MEMORANDUM

TO: District of Columbia Zoning Commission

SUBJECT: Public Hearing Report for ZC #08-30C
25 M Street, SE – Modification of an Approved Zoning Commission Design Review Under the Capitol Gateway Overlay

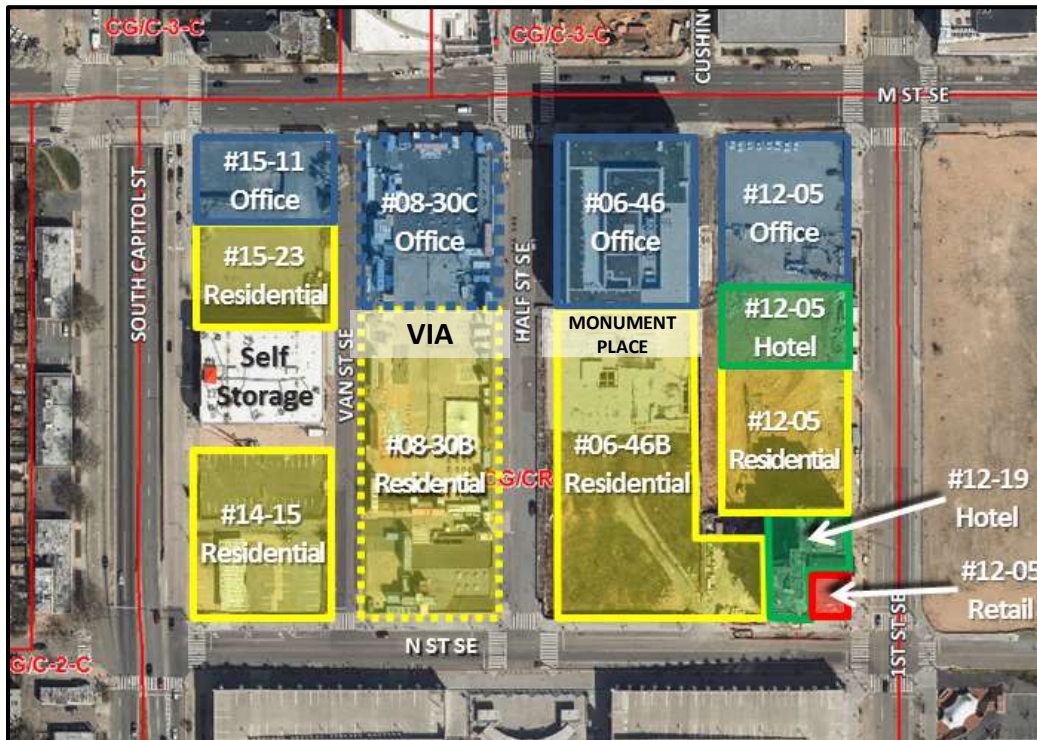
The applicant has applied for a modification to the design of this mixed use development originally approved by the Commission in 2009 and subsequently modified in 2011. This proposal includes a modification to the massing and architecture on the part of the site at M Street SE, north of the Via. The Office of Planning (OP) reviewed the application pursuant to the review criteria of Chapter 16 of the Regulations, the Capitol Gateway Overlay. The application generally successfully addresses the criteria of the Overlay and OP strongly supports the project. OP has requested that the applicant address the outstanding items in this report, and pending resolution of those issues OP would have no objection to the overall application.
